Access Compliance Report Public Rights-of-Way (Curb Ramps)

Main Street: 17TH_ST Cross Street: PROSPECT_AVE Location: NW

ADA ID: RPRK220124103617 Ramp Type: Type 1 - Perpendicular Diagonal Initial Pass/Fail: Fail Overall Compliance: No Severity Score: 15

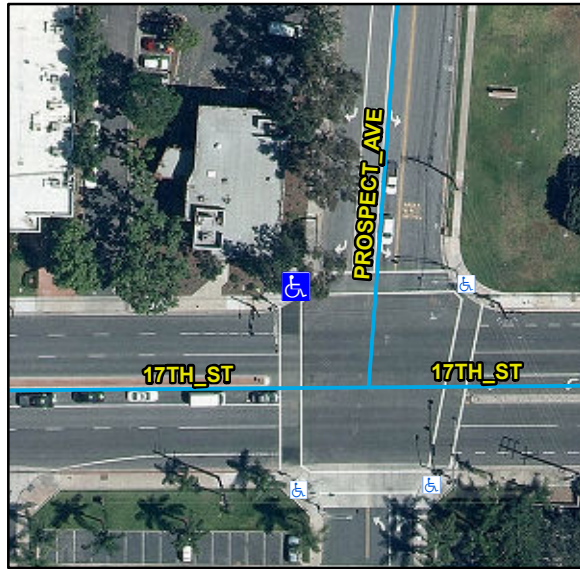
Compliance	Description	Data	Compliance	Description	Data
N/A	Ramp Length (in)	80	N/A	Flare Type LT	
Yes	Ramp Width (in)	48			N/A
No	Ramp Run Slope (%)	8.7	N/A	Flare Slope LT (%)	N/A
Yes	Ramp Cross Slope (%)	0.9	N/A	Flare Traversable LT	N/A
N/A	Landing Present	N/A	N/A	Flare Type RT	
N/A	Landing Length (in)	N/A			N/A
N/A	Landing Width (in)	N/A	N/A	Flare Slope RT (%)	N/A
N/A	Landing Run Slope (%)	N/A	N/A	Flare Traversable RT	N/A
N/A	Landing Cross Slope (%)	N/A	N/A	DWS Provided	N/A
N/A	Landing Movement Obstructed?	N/A	N/A	DWS Contrast	N/A
	Landing Movement Type	N/A	N/A	DWS Length (in)	N/A
N/A	Landing Shared	N/A	N/A	DWS Full Width	N/A
N/A	Clear Space	Yes	N/A	DWS Offset Left (in)	N/A
N/A	Clear Space To Crosswalk (in)	48	N/A	DWS Offset Right (in)	N/A
N/A	Marked Crosswalk 1	Yes	N/A	Marked Crosswalk 2	Yes
	Crossing 1 Direction	S		Crossing 2 Direction	E
	Marked Crosswalk 1 Width (in)	144		Marked Crosswalk 2 Width (in)	144

N/A	Ramp Inside Crosswalk 1	Yes	Yes	Ramp Inside Crosswalk 2	Yes
	Crossing 1 Slope (%)	5.1		Crossing 2 Slope (%)	0.8
	Crossing 1 Cross Slope (%)	0.3		Crossing 2 Cross Slope (%)	1
N/A	Gutter Ponding	N/A	N/A	Curb Slope	1.7
Yes	Gutter Lip Height (in)	0		Road Run Slope (%)	1.3
N/A	Gutter Run Slope (%)	N/A		Road Cross Slope (%)	4.6
N/A	Gutter Cross Slope (%)	N/A			
Yes	Overall Surface Condition: Acceptable		Yes	Perp Joint Present	Yes
	Cross Gutter Present?	No		Spandrel Present?	No
	Replace Cross Gutter?	N/A		Replace Spandrel?	N/A

Remove & Replace Curb Ramp With Two New Directional Ramps or Equivalent.

R304.2.2, STD 1115
